# Manual Supplement

Manual Title: 381 Calibration  
Part Number: Web Only  
Print Date: December 2010  
Revision/Date: 1, 6/12

Supplement Issue: **4**  
Issue Date: 4/17  
Page Count: 3

Figure 7. Current Test Simulated Voltage

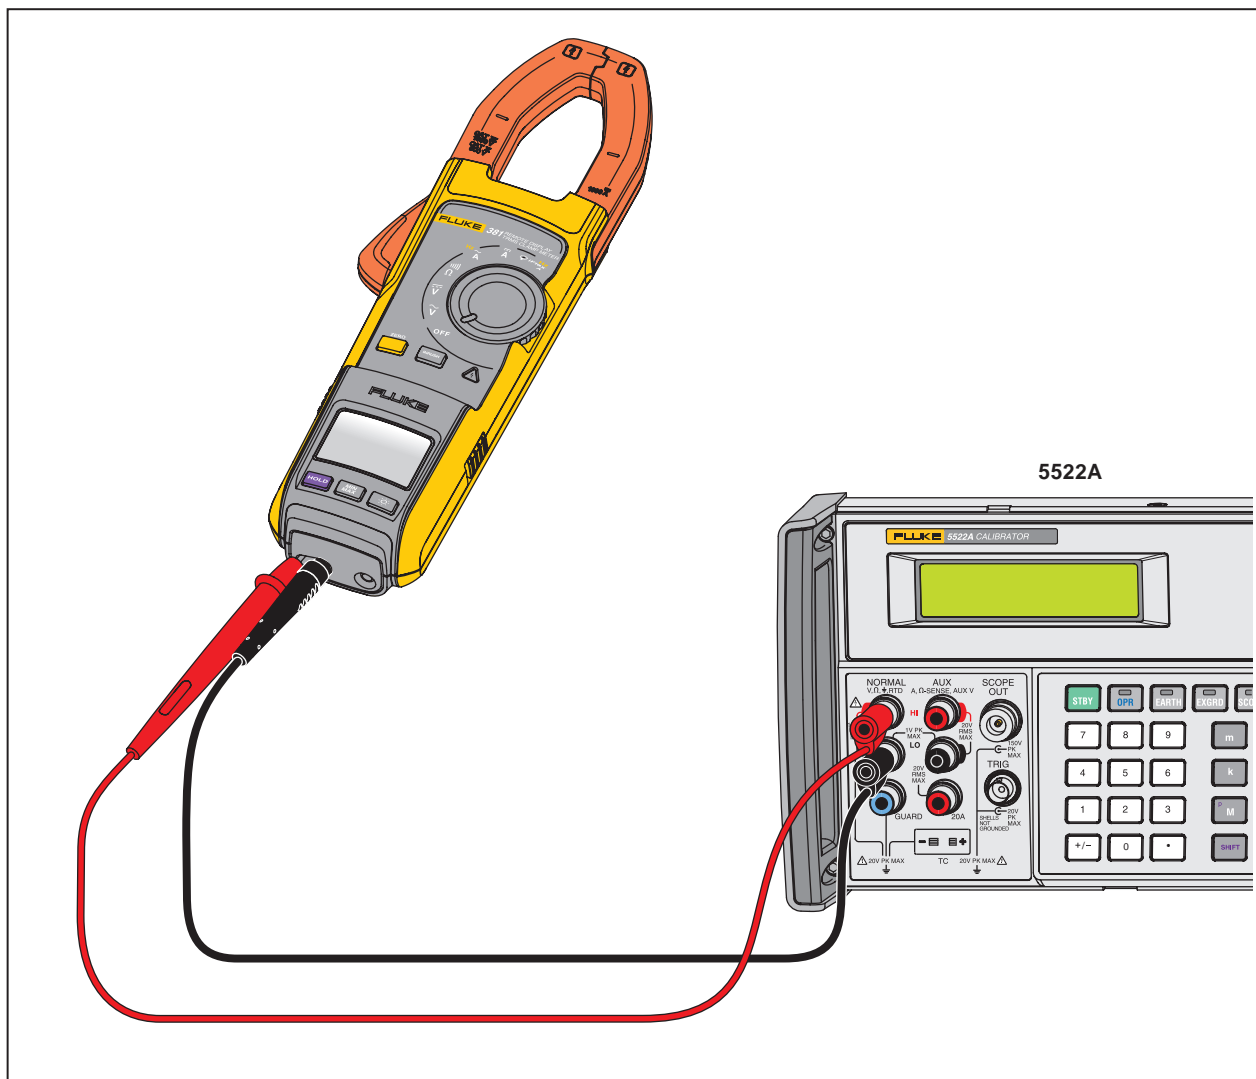
On page 14, replace Figure 7 with:

**Figure 5. Performance Test Connections for AC Voltage, DC Voltage, and Frequency**

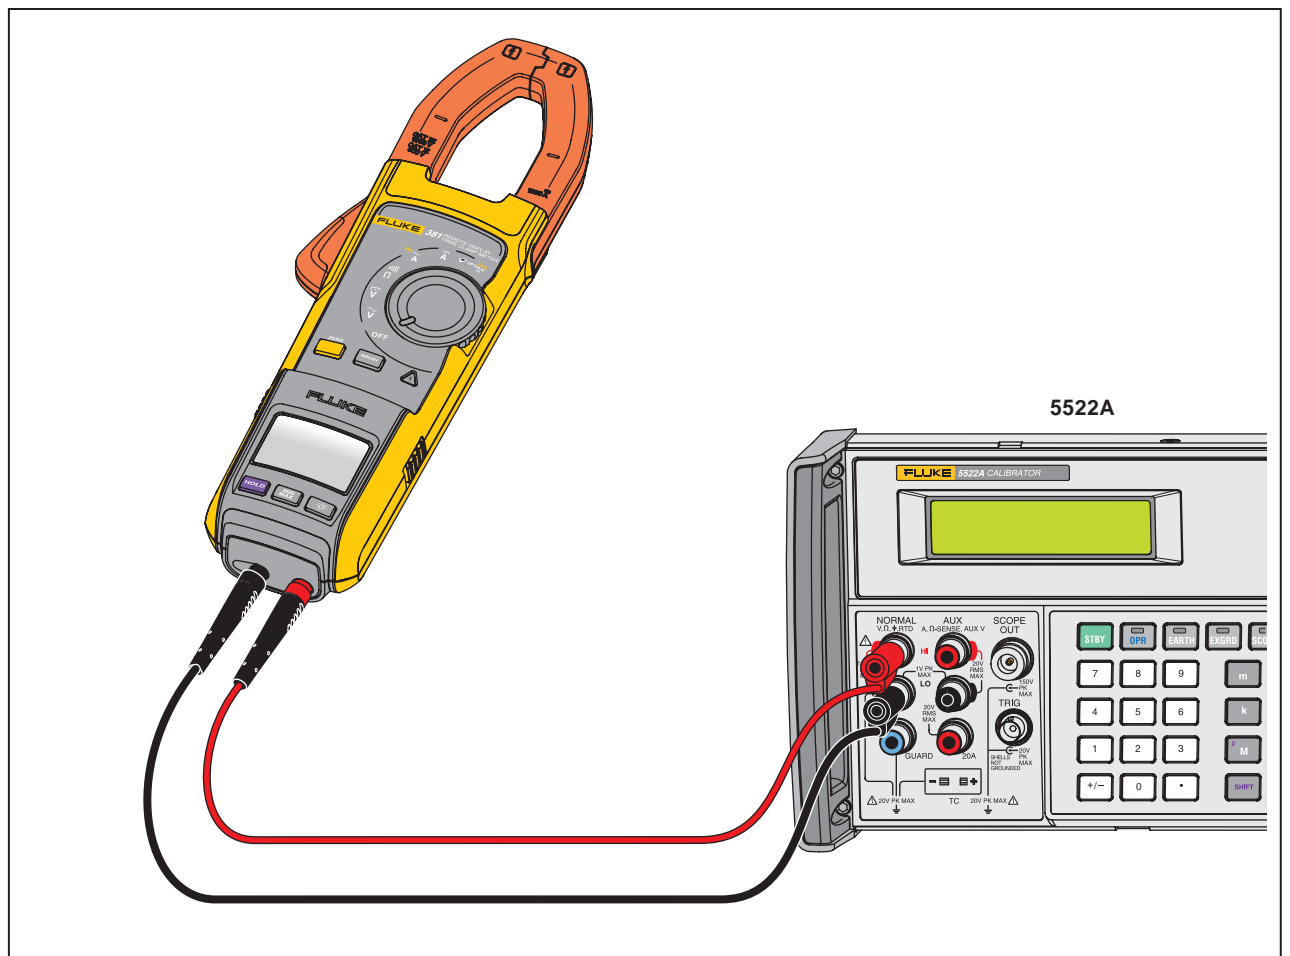
On page 10, replace Figure 5 with:
